**CITY OF BELLE MEADE
BOARD OF ZONING APPEALS
REGULAR MEETING AGENDA PACKET
JANUARY 23, 2024, 05:00 PM**

**AGENDA BOARD OF ZONING APPEALS
REGULAR MEETING
JANUARY 23, 2024, 05:00 PM
BELLE MEADE CITY HALL, 4705 HARDING PIKE**

Agenda No.: IV.A.
Case No.: BZA 2023-16
Staff: Mary Samaniego, Planning Director
Applicant: Jack Fleischer
Request: Approval of a Conditional Use for a Swimming Pool and two Variances for a fence in an alternative location and pool equipment outside of the building envelope.
Location: 112 Lynwood Boulevard

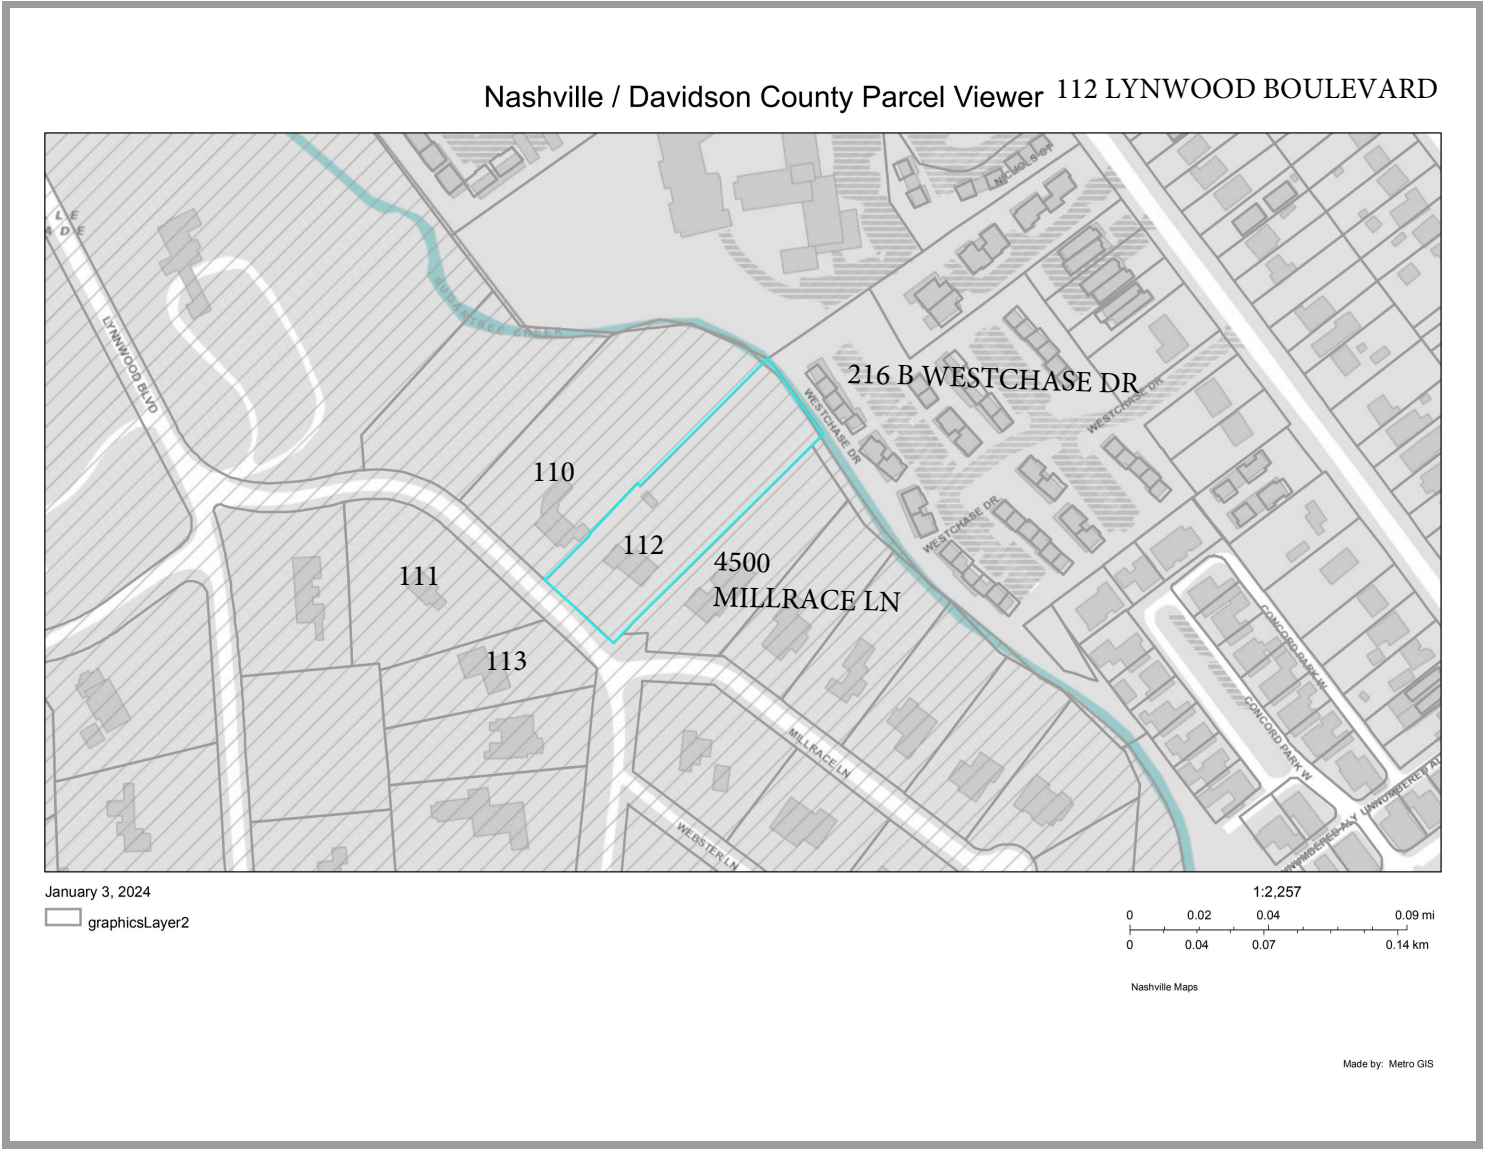
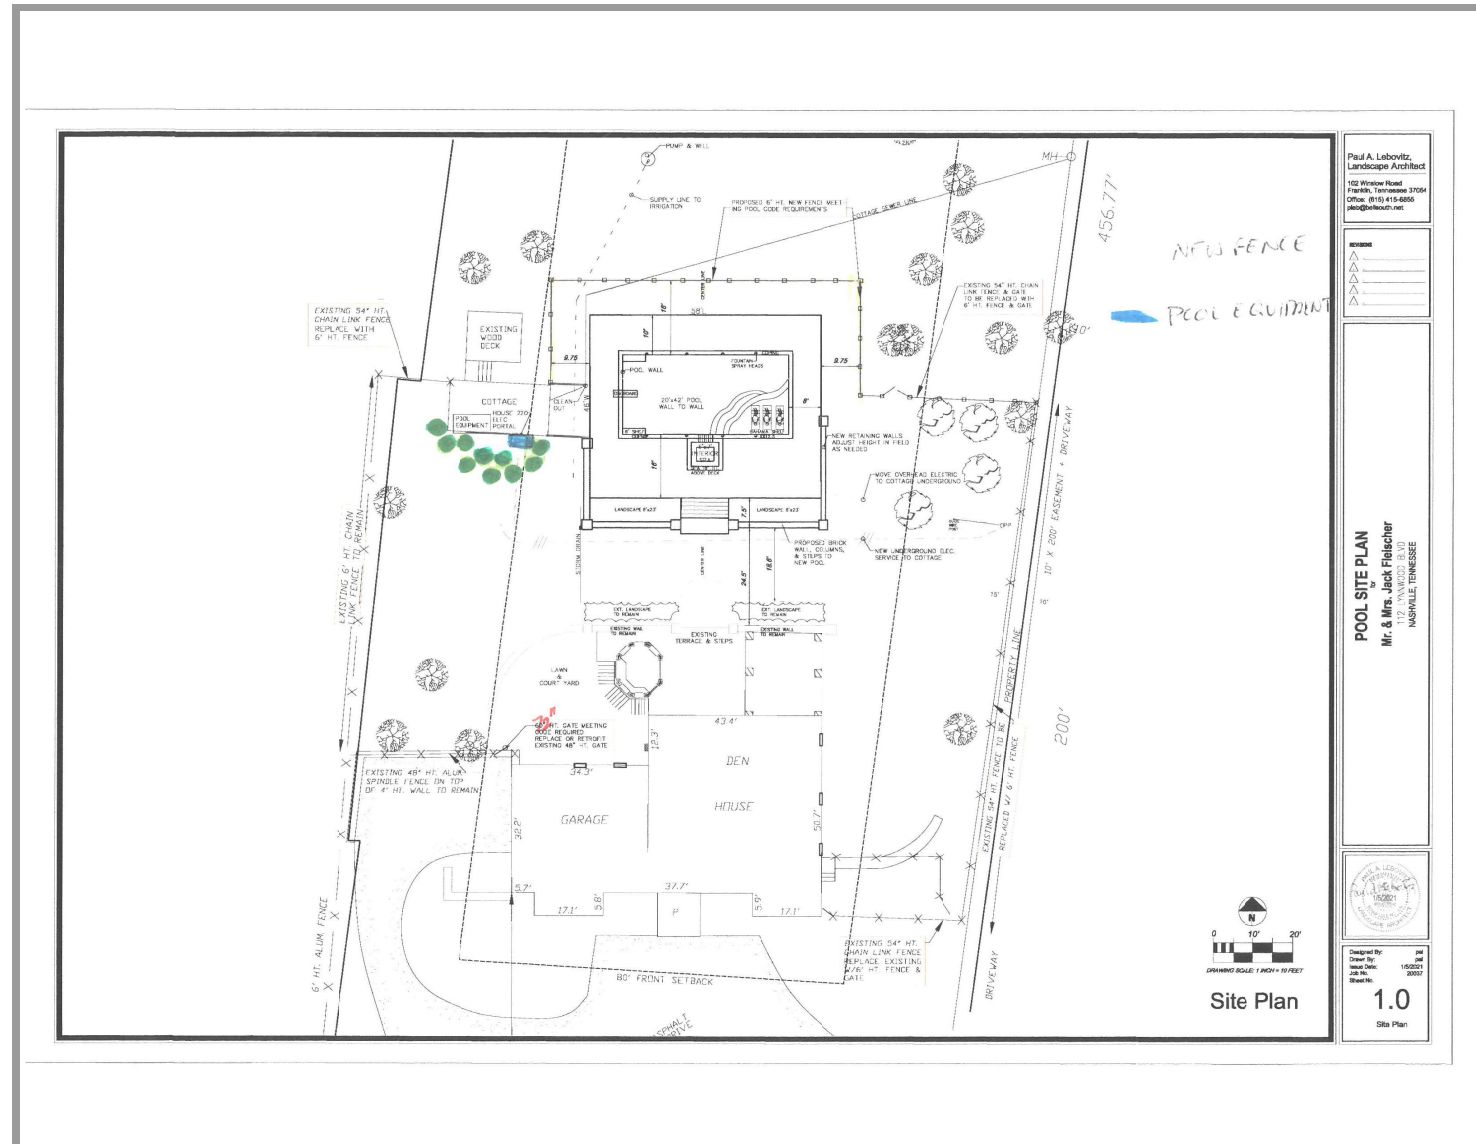
5. The proposed area of the hardscape including the pool is 2,785 square feet.
6. The proposed pool is entirely within the established building envelope (see attached Staff Analysis of Site Plan). The pool equipment will be outside of the building envelope.

7. The proposed 6' fence is at both the rear corners of the residence and continues to the side property line. However, the fence does not continue all the way to the rear property line but rather is 8' from the pool deck (see staff analysis).

8. The rear part of the property is in the regulatory FEMA floodway and constructional improvements (fences) are prohibited per the floodplain regulations in Section 12-407(3)(a).

1. The variance shall be granted that will not be a detriment to the public good;
The applicant is proposing to follow the required fence placement as close to compliance as possible with an existing fence while also recognizing the FEMA floodplain regulations prohibition of man-made obstructions to flood waters. While the placement of the pool equipment outside of the building envelope, it is adjacent to an existing accessory structure. The impact of the equipment located 4' outside the building envelope will not be detrimental to the public good.

2. The variance shall be granted that will not substantially impairing the intent and purpose of the Zoning Ordinance; and
The proposed fence does not meet the fence placement line as required. The intent and purpose of the fence provision, in staff's professional opinion, is to ensure that fences are placed in the rear yard as opposed to side yards. The proposed fence placement in the majority of the rear yard outside of the FEMA floodplain meets with intention of both the zoning ordinance and flood damage prevention ordinance. The subject property has slopes that decrease by approximately 30' from the front property line to the rear property line. The existing residence as well as driveway, terraces, and a cottage are all constructed with the use of soil retaining structures. Given the significant change in topography and placement of existing structures, the pool equipment placed just outside of the building envelope satisfies the intent of the zoning ordinance.

3. The resulting home will not be out of harmony with the other homes in the neighborhood.
The proposed fence will be placed on the lot out of sight of Lynwood Boulevard by the proposed and existing landscaping as well as the residence. Given this information, the impact on surrounding properties when viewing the property from the street is negligible in staff's professional opinion. The placement of equipment in front of the existing cottage will not be out of harmony with the surrounding area.

Staff recommends approval of the conditional use and the two variance requests based on the written findings of fact.

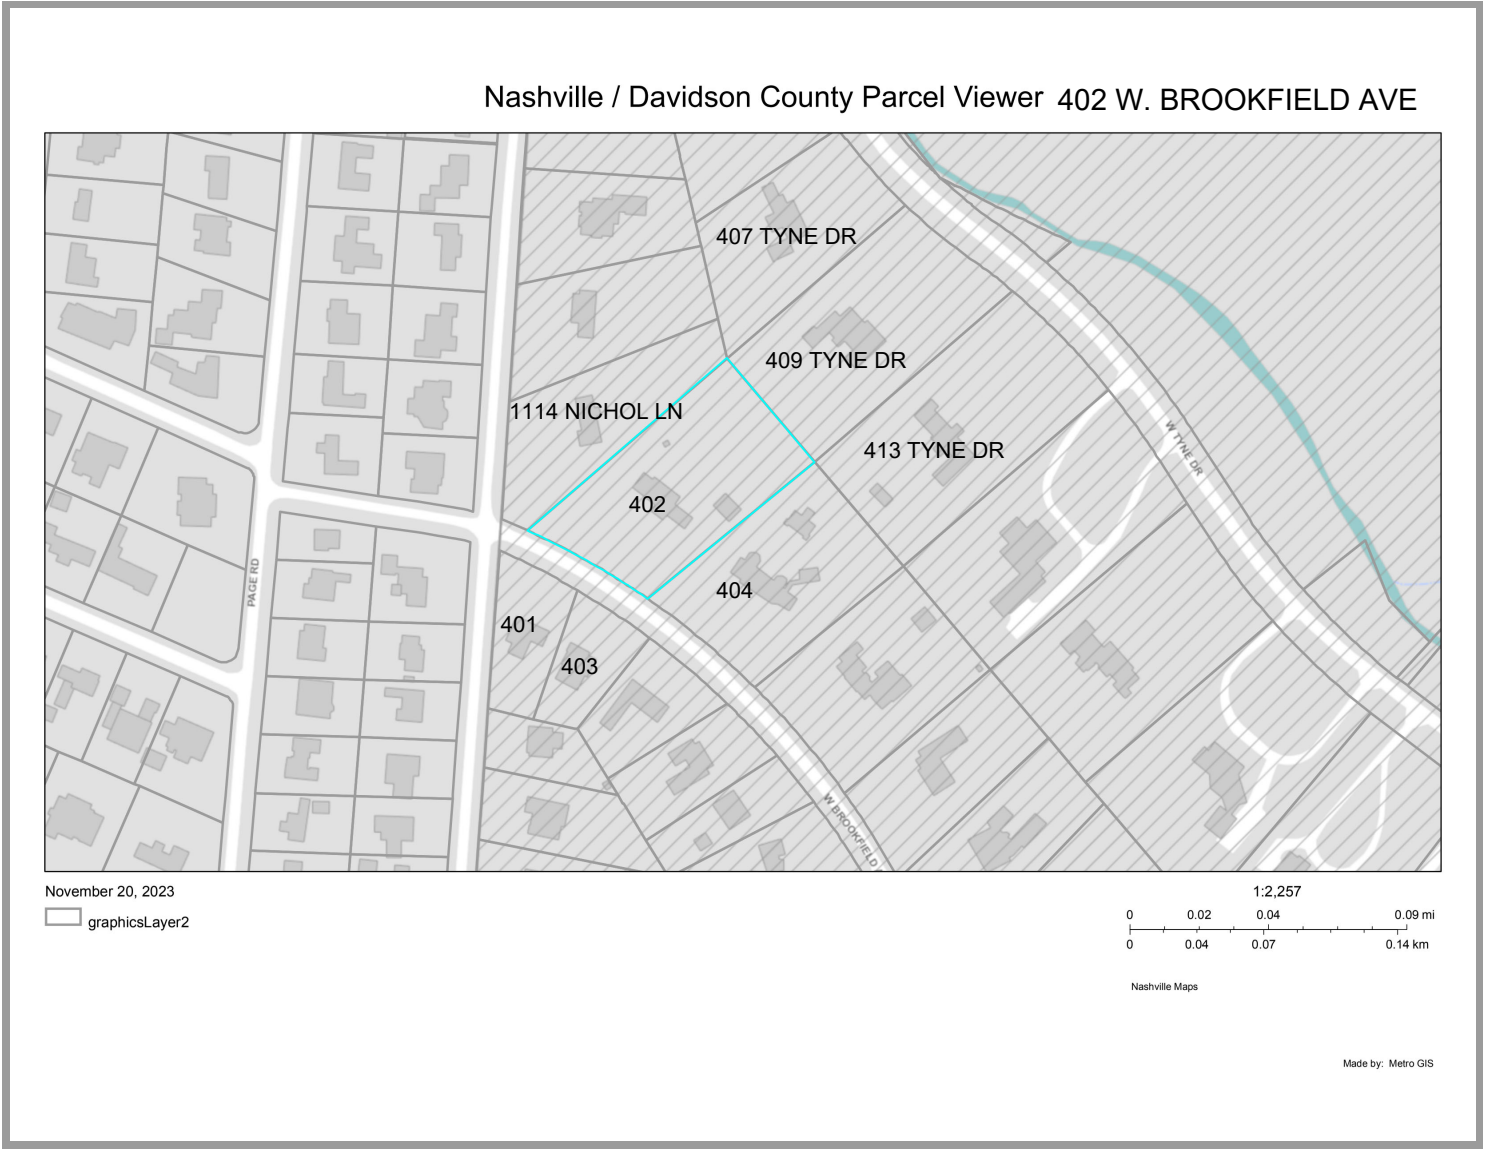
10. The proposed maximum accessory area is 13,652 square feet.
11. The proposed pool as well as equipment, pool house, and tennis court are entirely within the established building envelope (see attached Staff Analysis of Site Plan).
12. The applicant is proposing a 6' stone/chain link/metal fence that will begin and end at a rear side edge of the proposed residence, but not the furthest rear edge (see staff analysis). Therefore, a variance is required.

1. The variance shall be granted that will not be a detriment to the public good;
The applicant is proposing to place the fence to the rear of the residence but not at the furthest edge (see application site plan). From West Brookfield Avenue right-of-way, it will appear that the fence is at the back edge because the back edges are inset.
